PUD MASTER DEVELOPMENT PLAN
LAURA HEIGHTS
BEXAR COUNTY, TEXAS

Re: Laura Heights

MDP # 870

TO: Rolando H. Briones, Jr., P.E., Briones Consulting & Engineering, Ltd.
FROM: Ismael B. Segovia, Planner II, Development Services Department
DIVISION: Master Development Plan / Major Thoroughfare Plan
COPIES TO: Michael Herrera, Special Projects Coordinator, Development Services Department
SUBJECT: Galm Road (Laura Heights) MDP/PUD

PUD MASTER DEVELOPMENT PLAN
LAURA HEIGHTS
BEXAR COUNTY, TEXAS

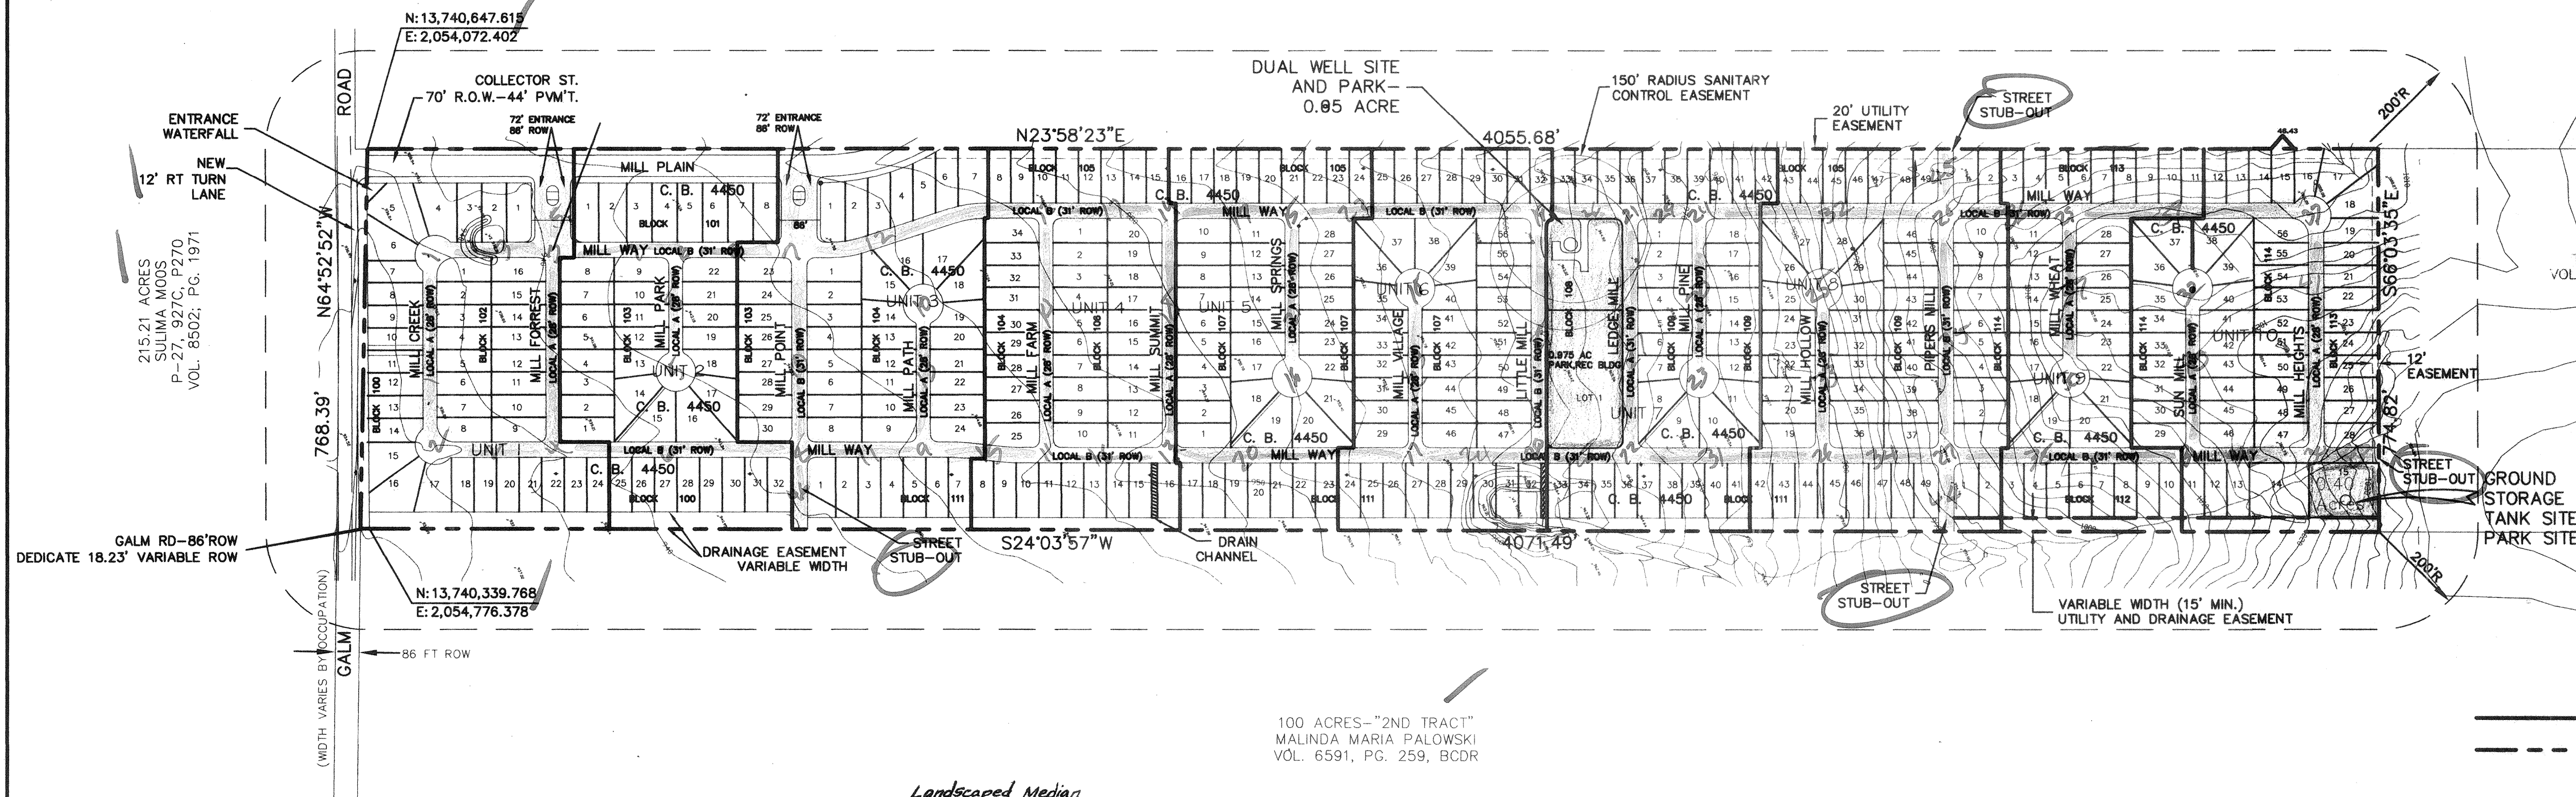
Final Redline
2/14/06

72 ft STREET SECTION @ ENTRANCE

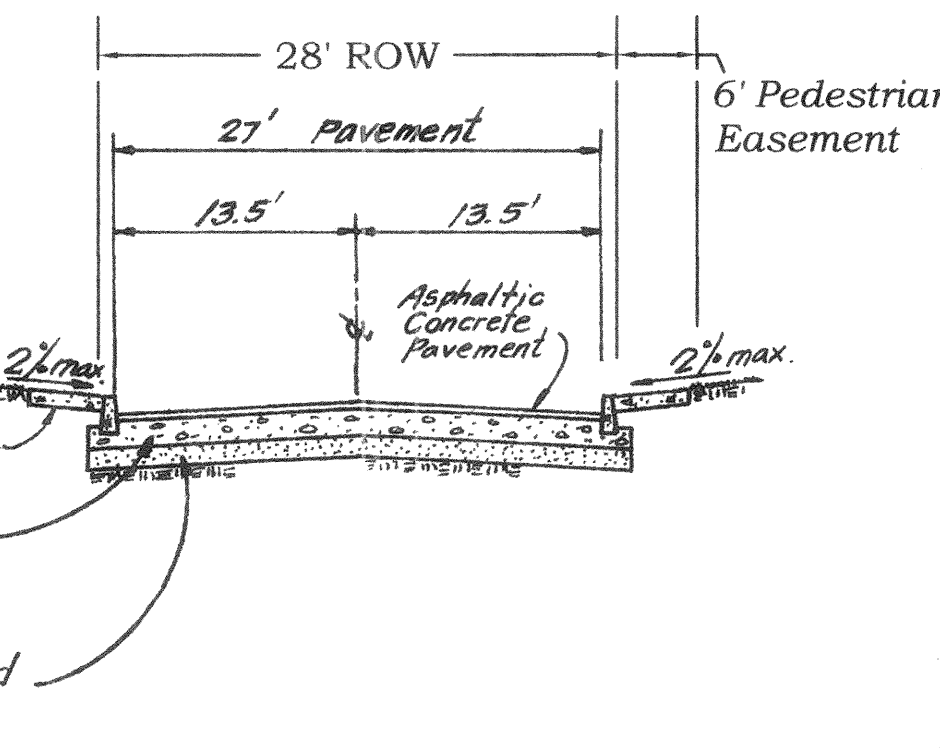
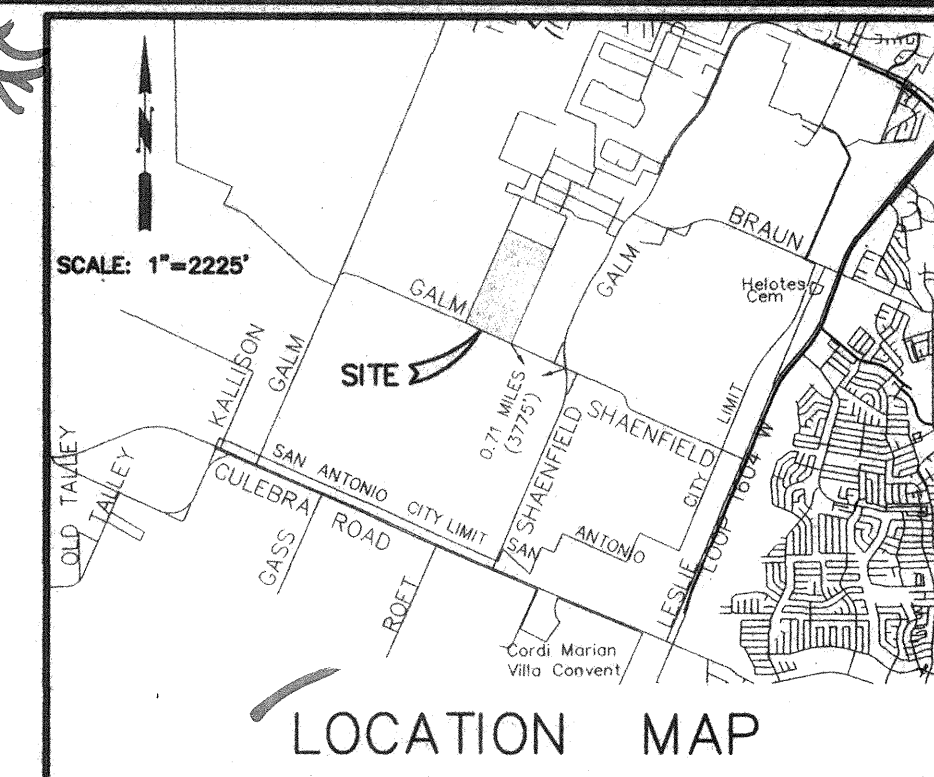
3) 275+ ROADWAY SECTIONS ARE FOR PRIVATE STREETS
PLEASE CALL OUT PRIVATE STREET ON TYPICAL

4) TYPICAL SHOWING LANDSCAPE MEDIAN ~~50 FT~~ 50 FT
MAX. ~~ACCORDING TO UDC~~ UDC CALLS FOR 14 FT
MEDIAN WITH 1/8 FT LANES ON EACH SIDE.

- Please provide the gated entry details on the PUD plan. Gated entries require adequate turn around prior to the gate (single unit vehicle)
- Show ROW dimensions on the street sections. Curbs and sidewalks must be within the ROW. Sidewalks may be in a pedestrian easement.

- Local "B" road required by the park/pool for on-street parking. No parking is allowed on 27' wide roadways.
- Add the following note: "Sidewalks shall be installed in all public and private streets in accordance with UDC 35-506(q)." Sidewalks are required along Galm Road. Six foot sidewalks are required if back-of-curb for collectors and Local "B" roads.
